RE: State Significant Development (SSD 5248) Condition C36A – Traffic and Transport Response

Momentum Industrial Estate, Eastern Creek

Concept design road safety audit

ASON-PROJ-0018-01 CD RSA 813-913 WALLGROVE ROAD Rev 5

Drawing Number:
AG.02

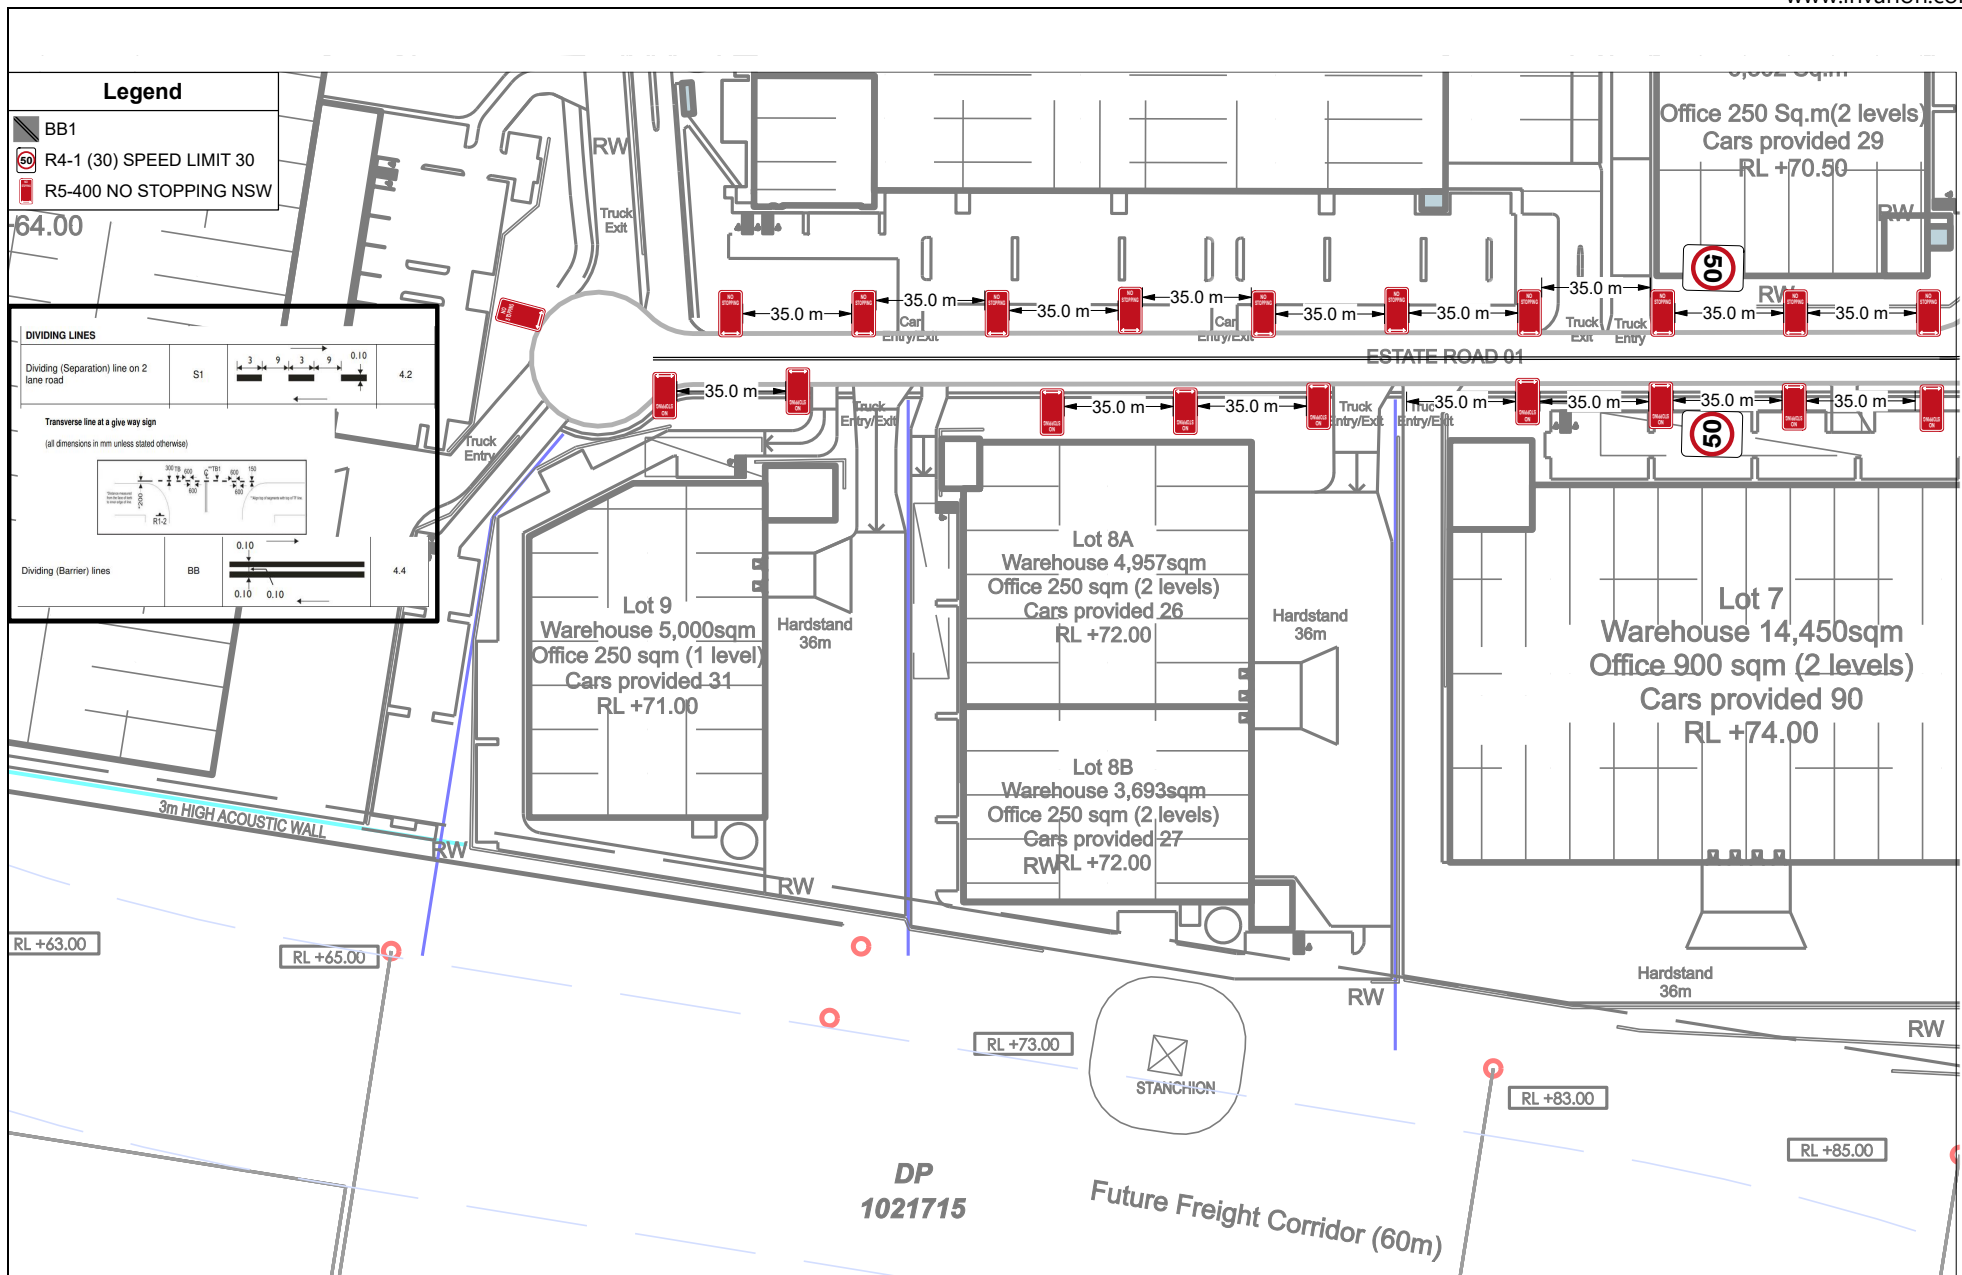
Ref	Location	Road safety audit finding	Risk rating
4	Unauthorised parking in the Estate Roads.	With the numerous warehouse facilities, one typical risk identified at other similar developments is the tendency for truck and trailer parking along the estate roads. This includes temporary layovers to complete log books and check loads etc, as well as long-term stays with both truck and trailer, and even trailers being parked by themselves. Such parking behaviour blocks access for other truck and vehicle movements. It also may block sight lines to and from side accesses. As the design progresses, and includes full signage and linemarking detail, strict controls will be needed with respects to parking and stopping along the estate roads.  <i>Left: Industrial estates such as this one in Honeycombe Drive, Eastern Creek, typically generate demands for on-street parking by trucks and their trailers.</i>	Low (Occasional + Limited)

To address this issue further Ason Group has prepared a signage and line marking plan (Please refer to **Appendix B**). It should be noted that the internal roads of the Estate are private. "No stopping" signs will be installed along the internal estate roads. Additionally, the Estate will only have one access point via a signalised intersection at Wallgrove Road.

The installation of "No Stopping" signs along the internal estate roads will ensure that no vehicle will legally stop on these roads at any time. It is also worth mentioning that every lot provides sufficient parking to cater for any and all vehicles traveling to any particular warehouse, as well as loading docks to accommodate the
